Description for Chages of A3LML-1610

Changed Items

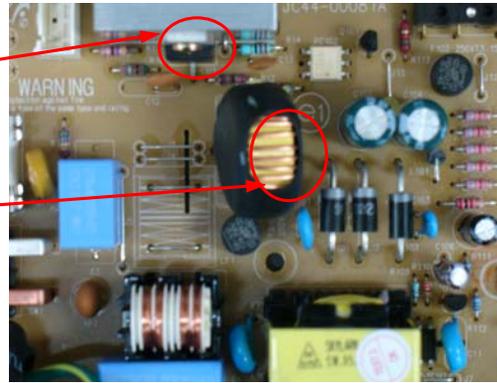
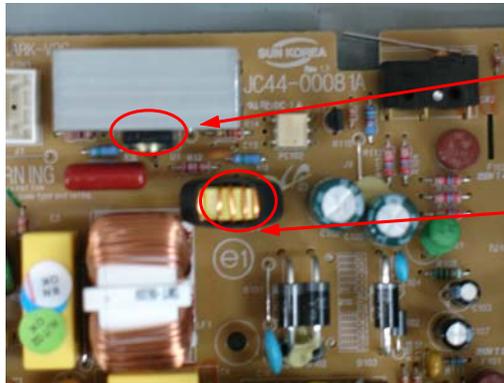
1. Adhesive section

- Changes for Triac U2 (16A → 12A), Coil L1 (30mH → 150mH)

2. Input Section

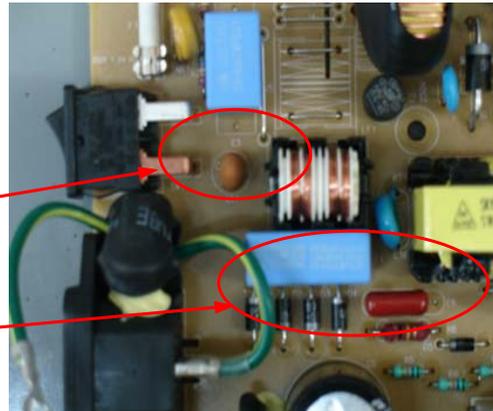
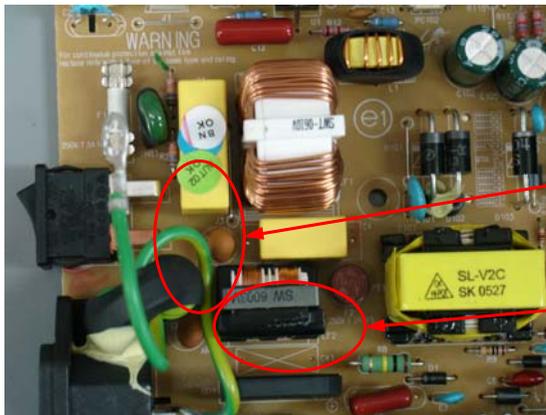
- Changes for Bridge Diode D1(Type: D3SB60 → GP20-6)
- Delete the Surge protector AR1(1EA)

3. Output Section

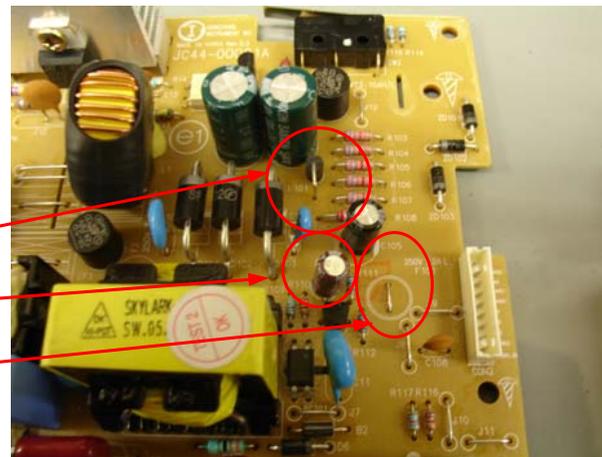
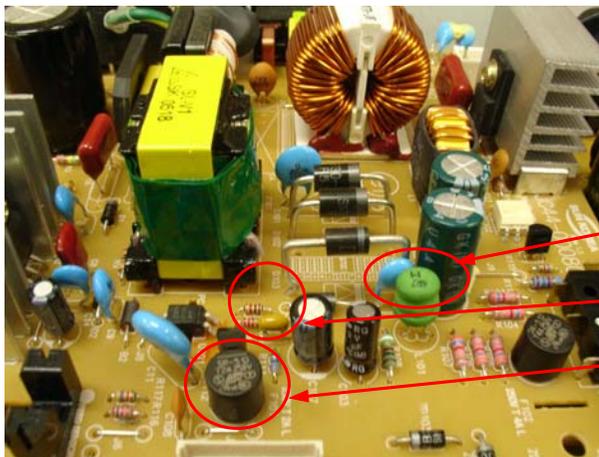
- Changes for Coil L101(Type: Inductor → Bead), Capacitor C106(Type: Mono → Electroytic)
- Delete the Micro Fuse in 5V line

4. Switching Section

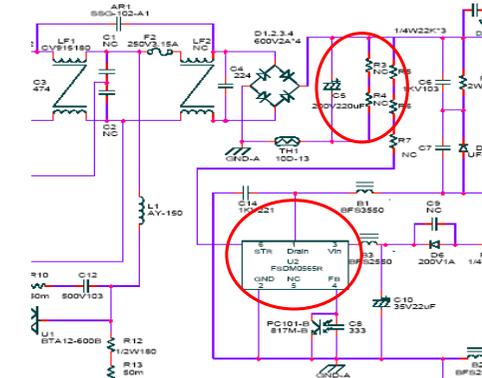
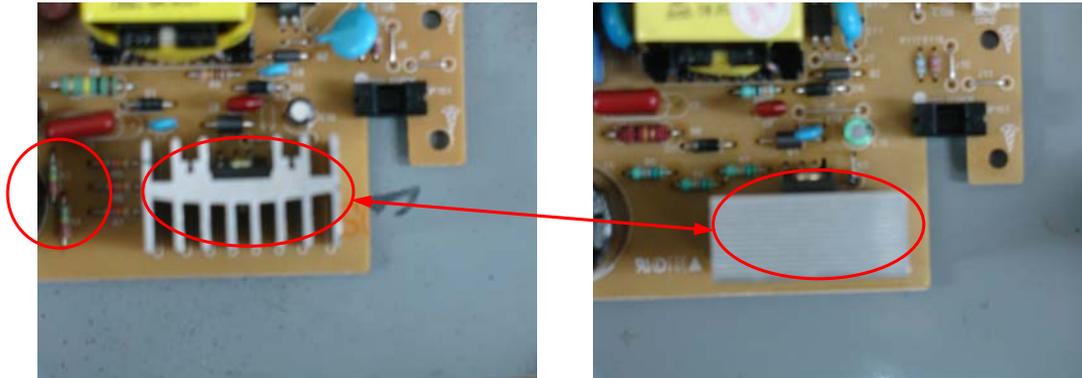
- Changes for **Heatsink Size**
- Delete the Discharge resistor R3 and R4
